Re: Comments on Notice of Proposed Amendment for Proposed 11th Edition of the Manual on Uniform Traffic Control Devices (MUTCD)

We are writing to offer comments on the December 14, 2021 Notice of Proposed Amendment (NPA) for the proposed 11th Edition of the Manual on Uniform Traffic Control Devices (MUTCD) on behalf of the Parking Consultants Council of the National Parking Association. The National Parking Association is the market leader in parking industry research, education, and advocacy that advances the industry, and its leaders and parking professionals. The NPA Parking Consultants Council (PCC), formed in 1972, is the prestigious, peer-reviewed group of over 40 vetted parking consultants with a substantial body of work experience and references within the parking industry. The Council is comprised of architects, engineers and parking management consultants. In addition, there are affiliate members who represent vendors in the parking industry, including several involved in parking guidance systems. The PCC fosters information sharing on standards, regulations and trends that impact parking construction, management and operations. It develops best practices and technical e

Image courtesy NCUTCD

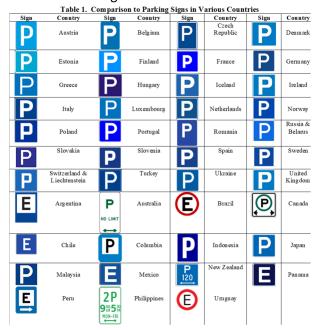
The Blue P is already recognized in MUTCD to stand for Parking, but the 2009 P with green circle is dropped in the 2020 NPA. D4-1 is frankly hideous, which discourages its use, particularly on SROPT. The Blue P is widely adopted and used throughout the world as seen in the compilation below.
